Access Compliance Report

Public Rights-of-Way

(Curb Ramps)

Intersection ID: N/A	Main Street: OLD_CONCORD_RD	Cross Street: ORCHID_BRIDGE_RD	Location: SE
ADA ID: 634412846A45	Ramp Type: Perp	Initial Pass/Fail: Fail	Overall Compliance: No
		Severity Score: 25

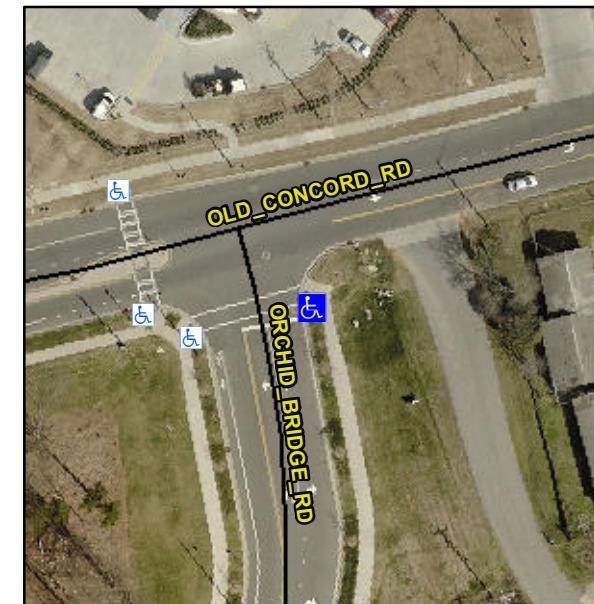
R304.5.3

Compliance	Description	Data	Compliance	Description	Data
N/A	Ramp Length (in)	97.0	Yes	Ramp Slope (%)	7.6
Yes	Ramp Width (in)	48.0	No	Ramp XSlope (%)	7.1
N/A	Flare Type LT	N/A	N/A	Flare Type RT	N/A
N/A	Flare Slope LT (%)	N/A	N/A	Flare Slope RT (%)	N/A
N/A	Flare Traversable LT?	N/A	N/A	Flare Traversable RT?	N/A
N/A	Landing Length (in)	N/A	N/A	DWS Provided?	N/A
N/A	Landing Width (in)	N/A	N/A	DWS Contrast?	N/A
N/A	Landing Slope (%)	N/A	N/A	DWS Length (in)	N/A
N/A	Landing X Slope (%)	N/A	N/A	DWS Full Width?	N/A
N/A	Landing Curb? (Y/N)	N/A	N/A	DWS Offset (in)	N/A
N/A	Shared Landing?	N/A			
N/A	Gutter Ponding?	N/A	N/A	Gutter Slope (%)	N/A
N/A	Gutter Lip Ht (in)	N/A	N/A	Gutter X Slope (%)	N/A
N/A	Painted X Walk1?	Yes	N/A	Painted X Walk2?	N/A
	X Walk 1 Direction	To W		X Walk 2 Direction	N/A
N/A	X Walk 1 Width (in)	92.0	N/A	X Walk 2 Width (in)	N/A
	X Walk 1 Slope (%)	2.4		X Walk 2 Slope (%)	N/A
	X Walk 1 X Slope (%)	4.1		X Walk 2 X Slope (%)	N/A

Remove & Replace Entire Ramp.
